**Re: City of Tacoma, Cowlitz River Hydroelectric Project No. 2016  
Mayfield Dam Downstream Fish Passage Improvement Plan,  
License Article 401 and Settlement Agreement License Article 2 (b).**

**Downstream Fish Passage Improvement Plan: Mayfield**

*Response to Comments on and Approval of License Article 401 and Settlement Agreement  
Article 2 (a),  
Draft Mayfield Downstream Fish Passage Improvement Plan*

***Mayfield Dam downstream fish passage facility, Fish Handling Diagram***

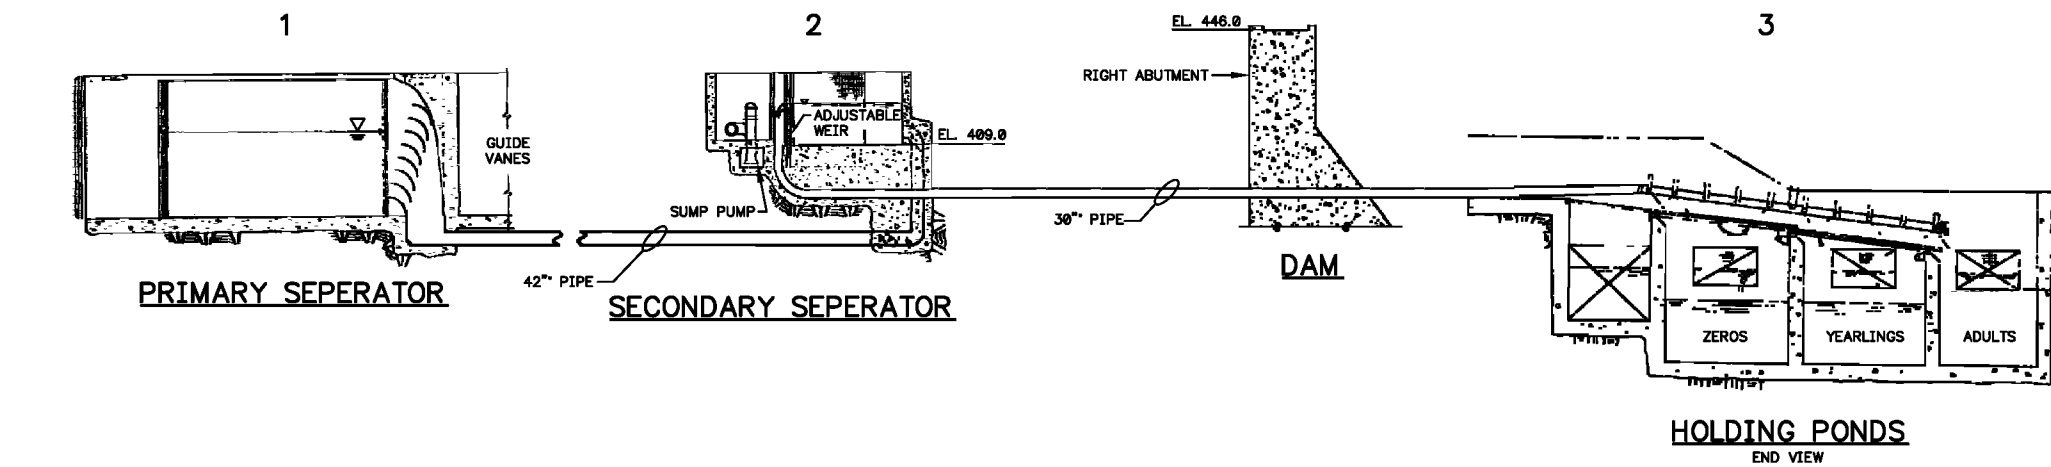
*There needs to be added a way to batch fish in the holding ponds similar to the current design, as well as within a holding pond before fish enter the volumetric tank.*
